GPU Nuclear Corporation

August 19, 1992
5000-92-3051
C321-92-2214

Subject: Oyster Creek Nuclear Generating Station (OCNGS)
Docket No. 50-219
Facility Operating License No. DPR-16
Oyster Creek Containment Peak Pressure Analysis

SRP COMPARISON FOR THE OYSTER CREEK PEAK DRYWELL PRESSURE ANALYSES

FIGURE 1

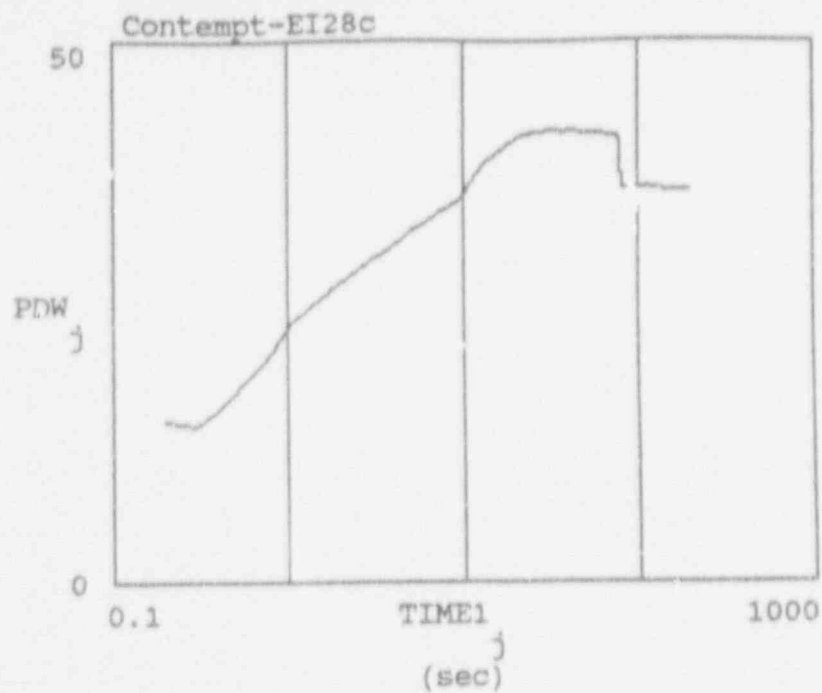
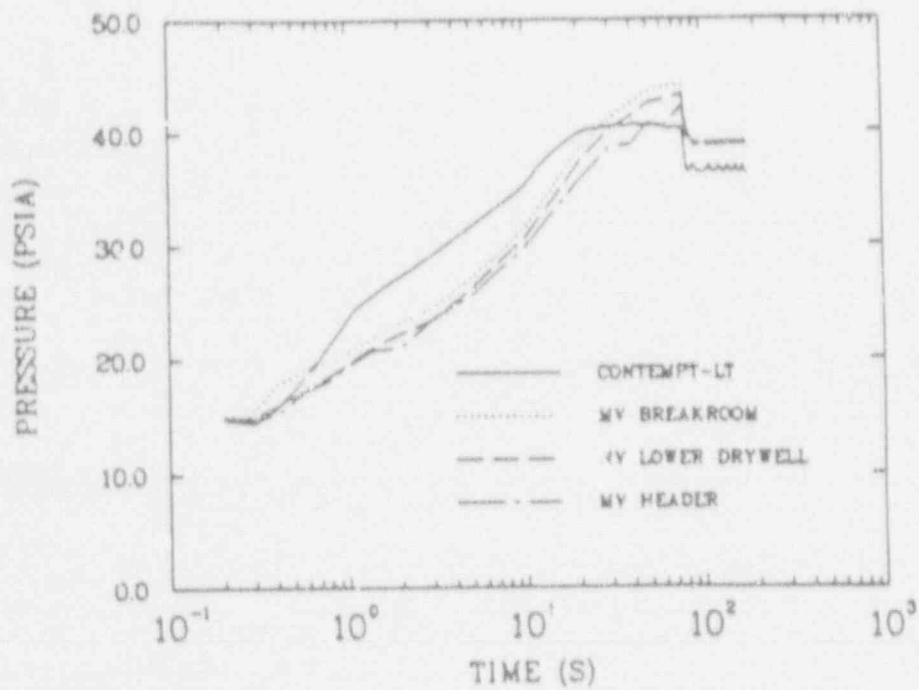
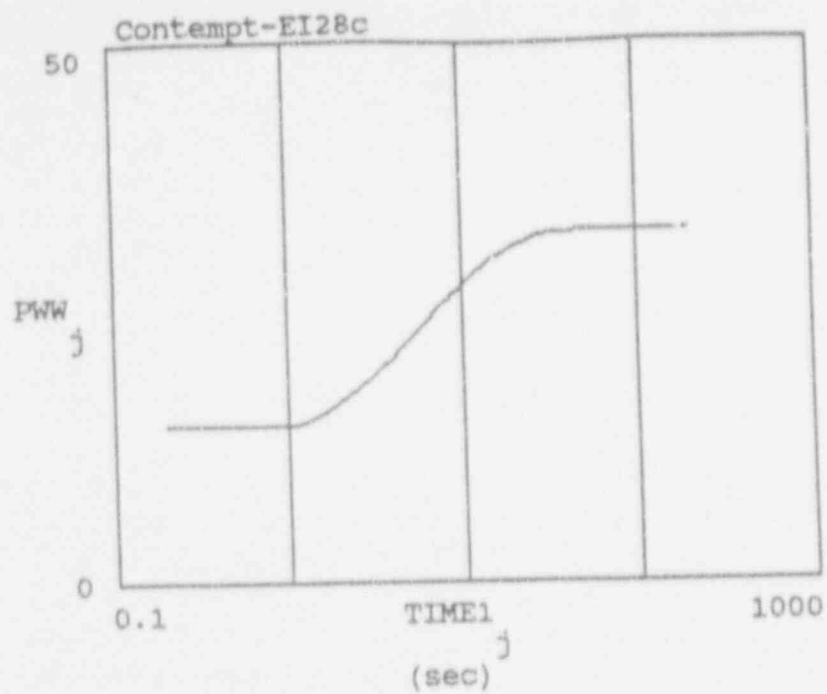
As can be seen in the table and in Figures 1 and 2, the calculated drywell and wetwell pressures for the two code versions agree extremely well. This confirms that no changes were made to EI 28C which would impact the Oyster Creek peak pressure analysis in a non-conservative manner. A comparison of all of the other key parameters shown in the attached table and in Figures 3 through 6 are similarly in excellent agreement between both code versions.
